V2500-A1/A5 SERIES PROPULSION SYSTEMS SERVICE BULLETIN

V2500-NAC-71-0293

NACELLE – POWERPLANT – FAN COWL DOOR – REWORK OF THE UPPER LOCATOR

Rework of the Fan Cowl Door Upper Locator
Figure 1

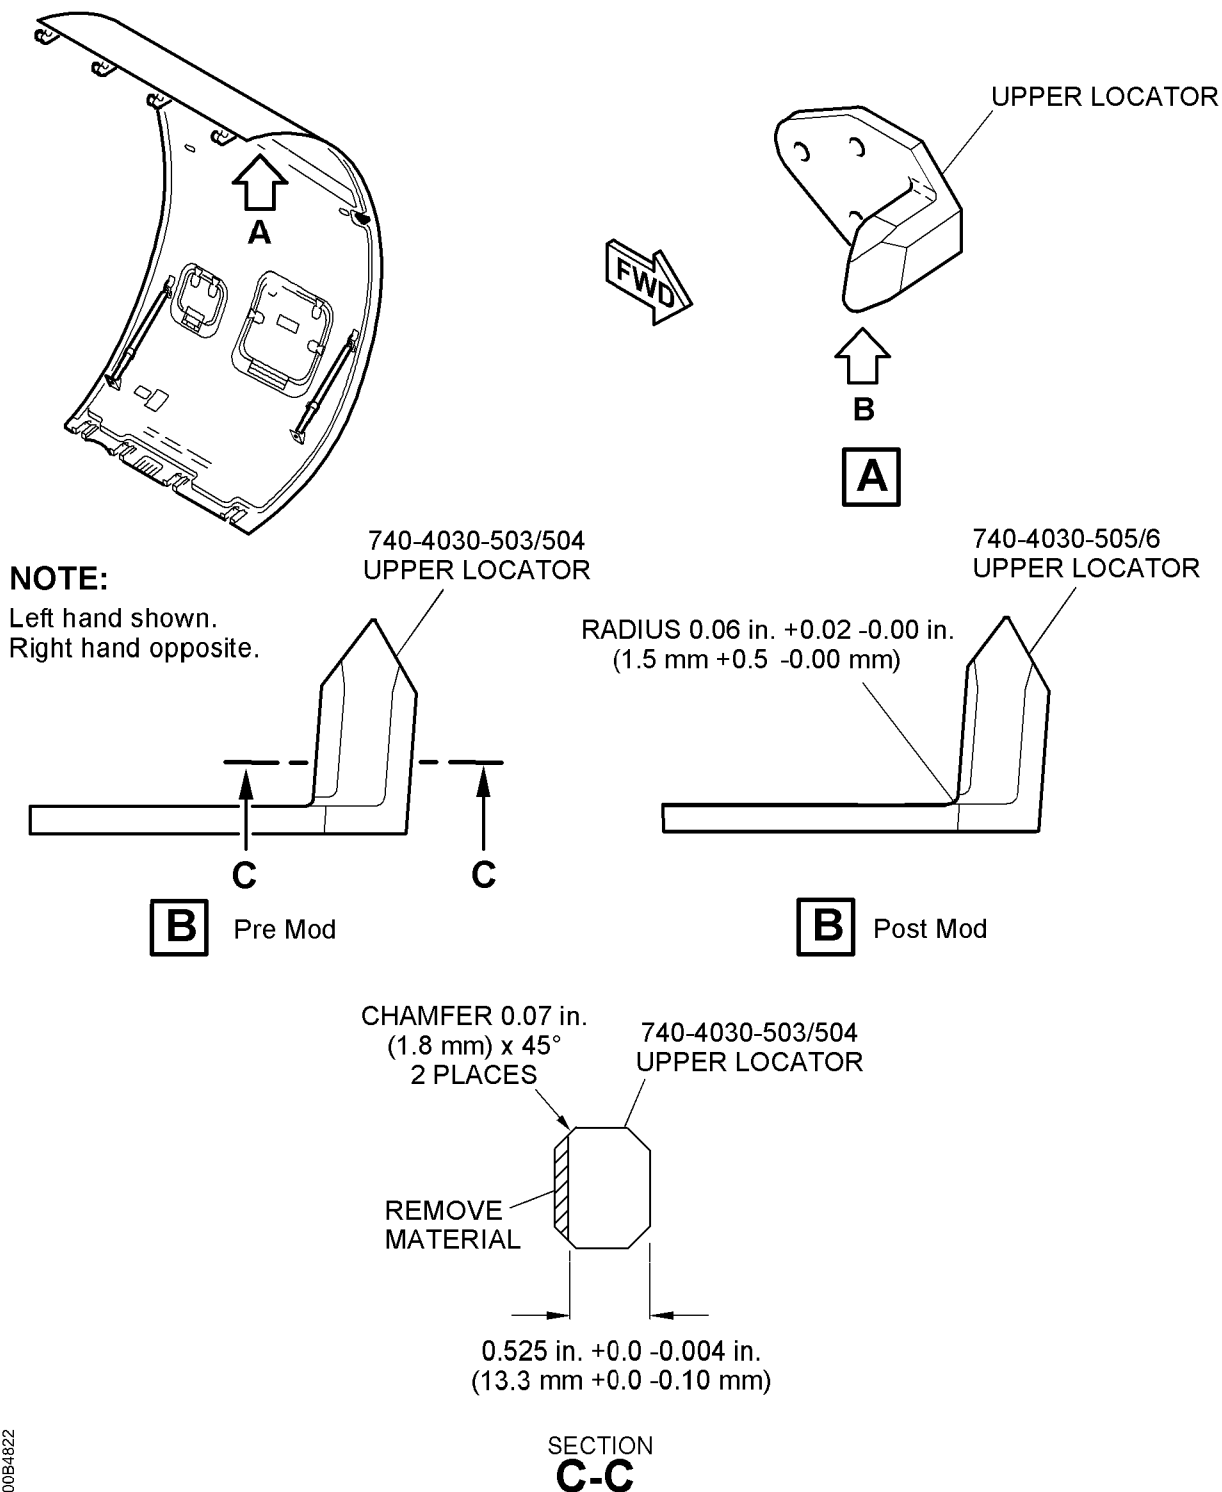
- (1) Find the 740-4030-503/504 upper Locator on the Fan Cowl Door. Refer to Figure 1.

- (2) Use the marking pen (CoMat 06-131) to mark the new profile onto the Locator as follows:

- A line of the new aft edge 0.525 in. +0.0 -0.004 in. (13,3 mm +0 -0.1 mm) from the forward edge.

- Two new corner chamfers 0.07 in. (0,18 mm) x 45 Deg.

- (3) Carefully remove the material from the Locator to suit new spigot profile. Make sure that you blend the new spigot profile at the base of the locator with radius 0.06 in. +0.02 -0.00 in. (1,5 mm +0,5 -0,0 mm). Refer to Figure 1, view B 'Post Mod'.
- (4) Deburr the cut metal edges.
